Historic Preservation Services

CERTIFICATE OF APPROPRIATENESS ISSUED: February 4, 2022 EXPIRATION: February 4, 2023

This letter provides you with confirmation that the proposed changes to your designated Fort Collins landmark properties, the Standard Block at 255 Linden and the Stover Drug Store Building at 261 Linden Street have been approved by the City's Historic Preservation Division because the proposed work meets the criteria and standards in Chapter 14, <u>Article IV</u> of the Fort Collins Municipal Code.

CONSTRUCTION
DOCUMENTS FOR THE
MASONRY, PARAPET
AND WINDOW
RESTORATION

255 Linden/Standard Block – upper windows proposed for replacement.

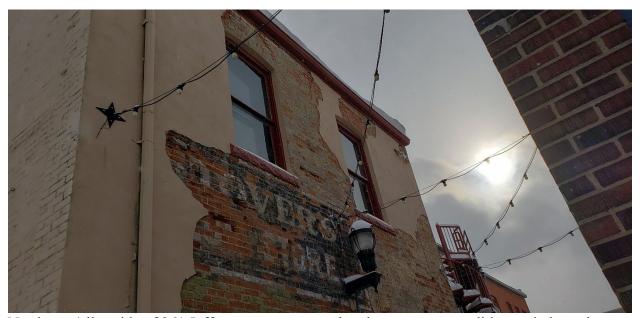
Restore, repair, and rehabilitate existing wood windows, including sash upper windows and storefront picture windows, and replace four replacement windows (on upper floor of 255 Standard Block) consistent with project plans. a. This element meets this Standard. The majority of windows are proposed for repair and rehabilitation. The four windows on the upper façade of 255 are non-

historic replacements, likely from the c.1983 restoration, that are deteriorating. In-kind replacement is proposed.

- 1) Restore, repair, and rehabilitate existing wood windows, including sash upper windows and storefront picture windows, and replace four replacement windows (on upper floor of 255 Standard Block) consistent with project plans.

North corner of 261 Jefferson at upper story, showing masonry deterioration and sandstone cap.

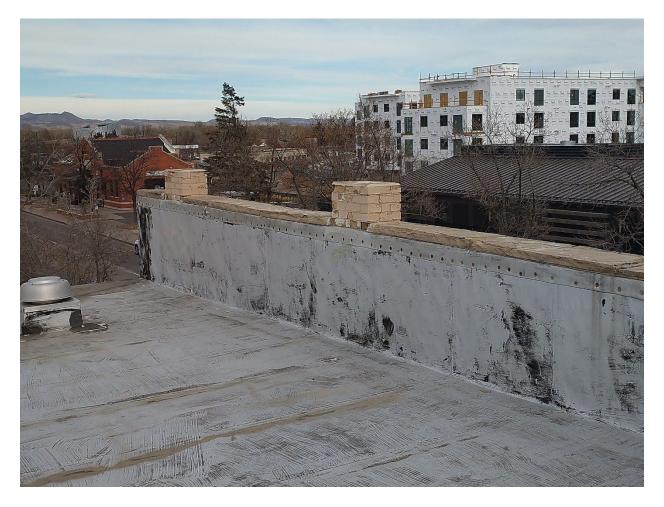
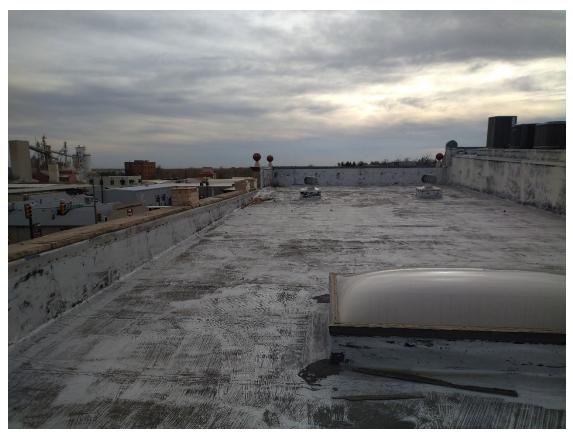
- a. The need for deconstruction and reconstruction of the upper sections of 261's masonry wall along Jefferson Street is apparent. This will primarily involve salvage and re-installation of the existing brick, and replacement in-kind where bricks have deteriorated too heavily to be serviceable. While the replacement of sandstone at the parapet cap is not ideal, a new, wider cap is needed both due to the deterioration of the cap itself due to freeze/thaw cycles and due to the water infiltration into the roofing system and masonry walls. The proposed in-kind sandstone cap will meet this Standard. The originally proposed concrete cap would replicate this design feature sufficiently, and with the feature located on the second story and not readily visible from the street, would be an acceptable treatment as well. This treatment resolves an important building health concern and meets this Standard.

4) Deconstruct/reconstruct upper masonry along northeast (Jefferson Street) elevation; remove historic sandstone parapet caps and install new sandstone caps to cover full wall. a. The repair of the upper parapet on Jefferson Street meets this Standard. The replacement of the parapet cap, although not ideal, appears necessary due to the freeze-thaw damage aggravated by the current cap. The in-kind replacement with a sandstone cap large enough to cover the full wall will meet this Standard.

a. The repair proposed for the brick sections of the parapet meet this Standard as they will generally just reconstruct with the existing historic material with new mortar joints. Regarding the sandstone cap on 261, the condition of this feature is mixed. Some of the stone caps are cracked and allowing water to channel directly into the brick wall structure, causing the visible deterioration. Much of the parapet cap would need replaced regardless. The replacement of the cap in-kind with wider sandstone meets this Standard. The option of replacement of the cap with the cast concrete would also preserve the design of the parapet, and improve building health, with minimal loss of historic materials. This treatment meets this Standard.	
SOI #7	Chemical or physical treatments, if appropriate, will be undertaken using the gentlest means possible. Treatments that cause damage to historic materials will not be used. Both the paint removal and finish restoration, as well as the brick repointing, appear to meet the appropriate preservation guidance regarding care with masonry of this age (1882 for 255 Linden, 1884 for 261 Linden). However, if paint removal methods begin causing damage in the field, work should stop immediately, focus on removing loose paint, complete the necessary repointing as needed for both buildings, and apply new finishes overtop of the existing. Breathable paint types that avoid trapping moisture in the masonry wall are strongly encouraged.	Y

- a. Note 1: Phone conversation with Kevin Murray (contractor) February 2, 2022 new sandstone caps will be installed with wider dimensions to address water infiltration into roof/wall system. Mason will set at angle to improve water shedding. If the originally-proposed concrete pre-cast is needed instead, this is also acceptable.
